PUBLIC NOTICE
CITY OF BEXLEY
ARCHITECTURAL REVIEW BOARD
BOARD OF ZONING AND PLANNING

a. Application No.: BZAP-20-3

ARB Request: The applicant is seeking architectural review and a recommendation to the Board of Zoning and Planning, to allow a 676 square foot, detached garage that is 22'9" in height, to be constructed in the rear yard.

New 2-car detached garage with second floor storage space.

EXTERIOR ELEVATION - House + Garage

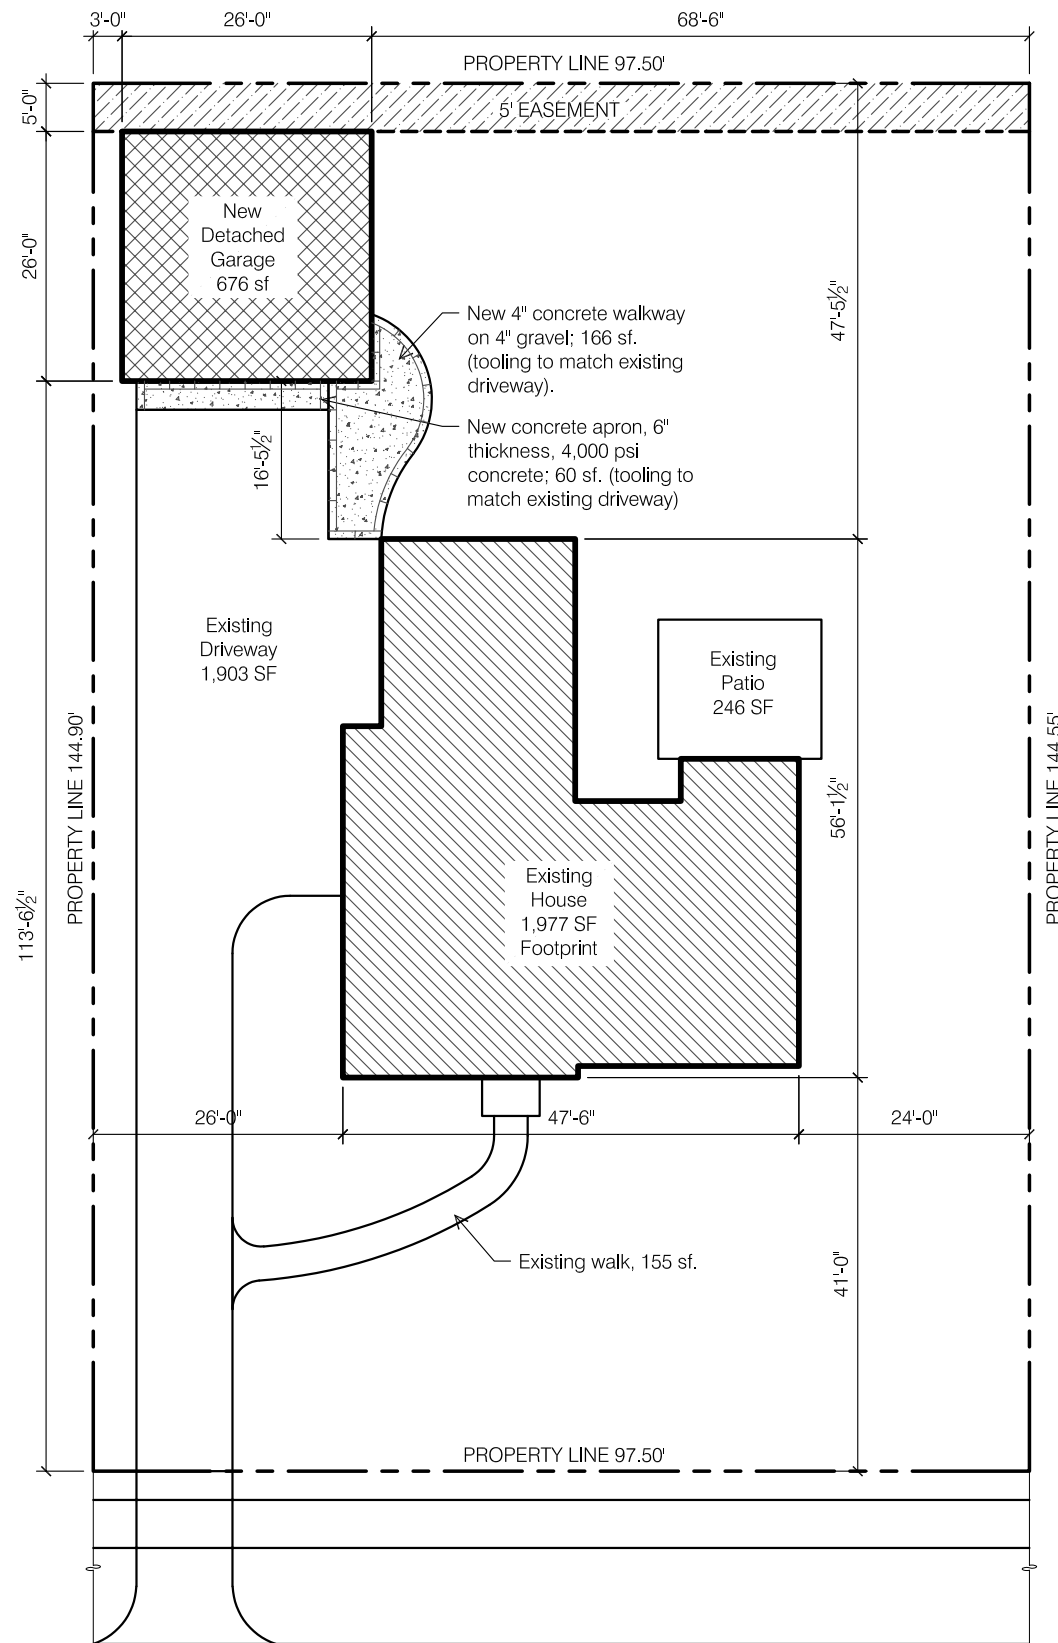
I understand and have included that in the Notice sent to neighbors. I also think it would be most helpful to show the proposed garage and existing principal structure together in a scaled plan to allow Board Members to compare the size of the proposed garage with the existing principal structure.

Floor plan or exterior elevation?

elevation - Thanks!

I just uploaded the exterior elevation of the house with the garage in the background. The file is "2020.0305 2700 Sherwood Exterior Elevation House-Garage".
